DOCUMENT NUMBER: FM-000-0004-48	TITLE: Form - Product Change Notice	
REVISION: H DCO# DC0005391	DOCUMENT CLASSIFICATION: 04-Forms, Templates or Other

PCN Number: PCN48801311-0001 **Revision:** B **Creation Date:** 22 Sep 2023

Part Number	Item Description
48-8013-11	ASSY,CARTRIDGE,INTELLIXCAP,96,MATRIX,INT

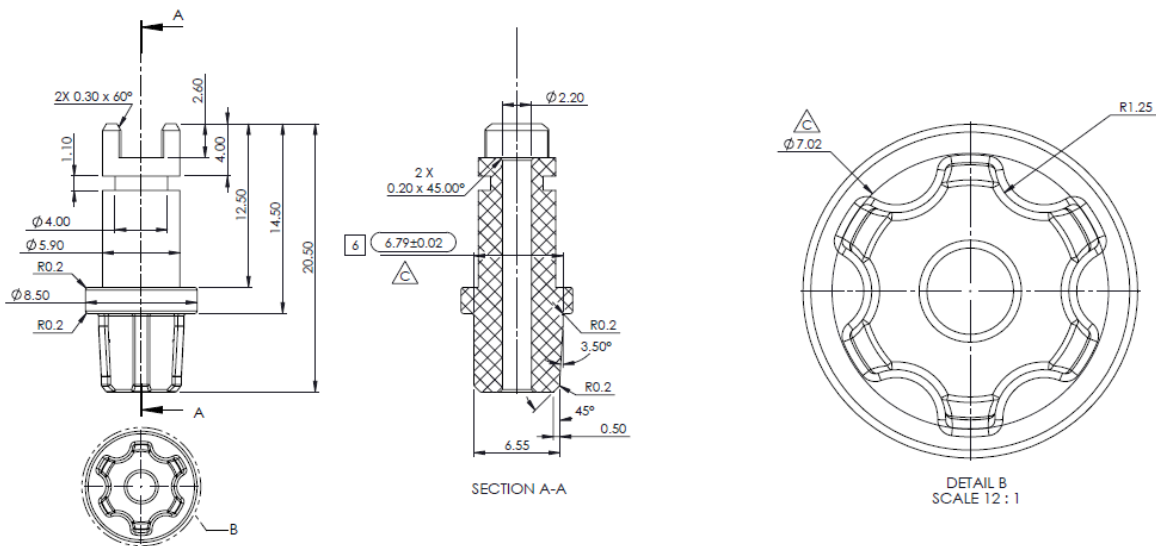
With the earlier revision of the IntelliXcap Automated Screw Cap Decapper Cartridge, 96 format, for *Thermo Matrix* internal thread (48-8013-11), it has been sporadically reported that some of the tubes were being forced into the rack during the decapping cycle, sitting lower in the rack than the remaining of the labware.

Hence, to overcome the reported issue and to improve the cap driver engagement with the Matrix Internal caps, a new cap driver for the Matrix cartridge has been designed.

The new cap driver has been designed to improve engagement with the caps. Please see below, for information only, the new design of the affected part, with the new dimensions and geometry:
